**DISCUSSION OF THE GEOLOGIC  
NON-SUITABILITY OF THE U.S. DEPARTMENT  
OF ENERGY'S SE-5 AREA FOR DISPOSAL OF  
HIGH-LEVEL RADIOACTIVE WASTE:  
A SUPPLEMENT TO THE GEOLOGY OF THE  
SANDYMUSH AND CANTON QUADRANGLES,  
NORTH CAROLINA**

**SUPPLEMENT TO BULLETIN 90**

**NORTH CAROLINA GEOLOGICAL SURVEY**

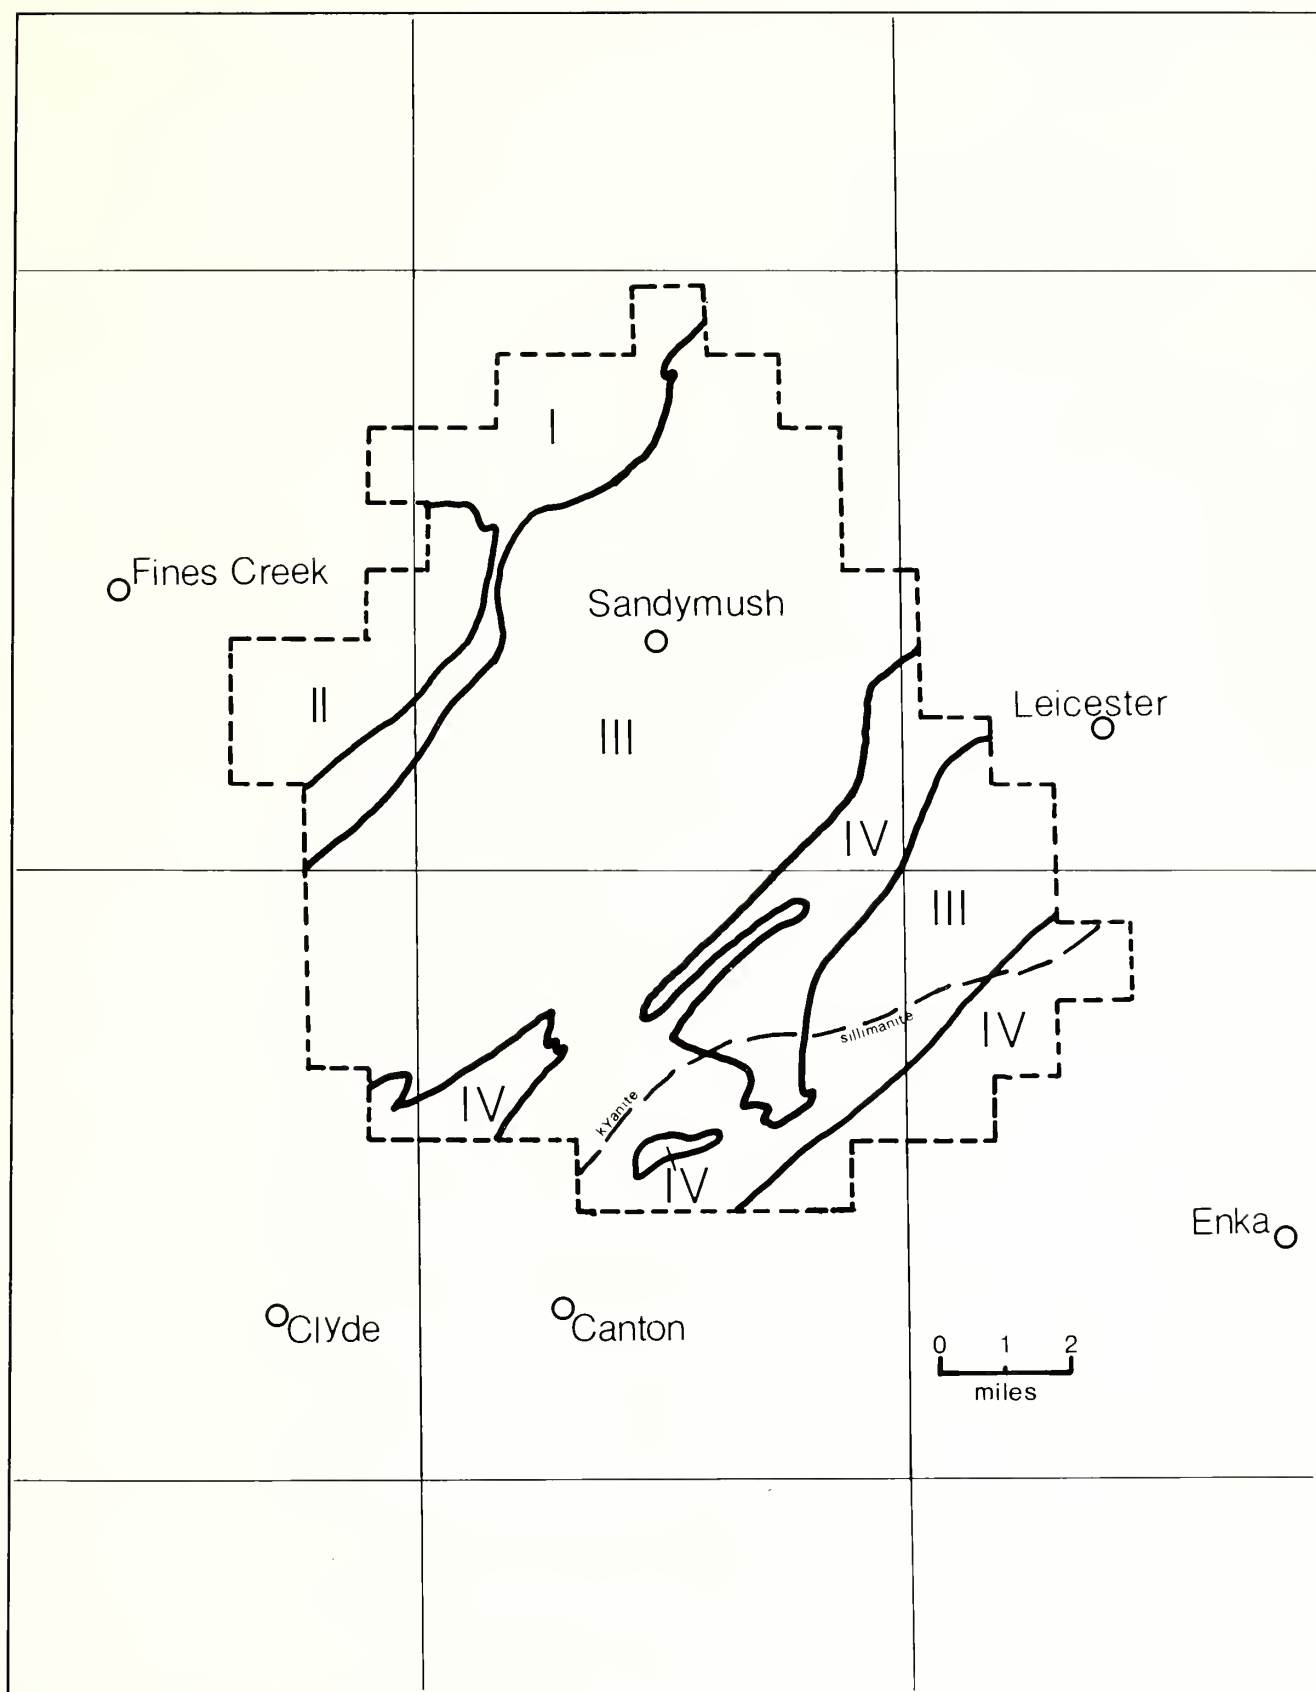
(1) has been metamorphosed, in part to lower amphibolite facies, and in part to upper amphibolite facies as indicated by the presence of sillimanite. Upper amphibolite facies rocks of this group are present in only three small separated areas. One area comprises about 1.25 square miles, and another about 1 square mile. The third area covers about 1.5 square miles on the Canton Quadrangle and about 3.5 square miles on the adjoining Enka Quadrangle (figure 3).

Most of the area underlain by Group IV is metamorphosed below upper amphibolite facies as kyanite, not sillimanite, is present (note location of sillimanite-kyanite isograd in figure 3). The rocks in only three, small, isolated areas attained upper amphibolite facies. However, in these areas too much schistose and non-granoblastic material is present to meet the stated criteria. Furthermore, two of the areas are not nearly extensive enough to meet the design requirement of 2,200 acres (about 3.4 square miles). The third, and largest area, is along the southeast border of the SE-5 site where there is not enough space for the requisite buffer and control zone.
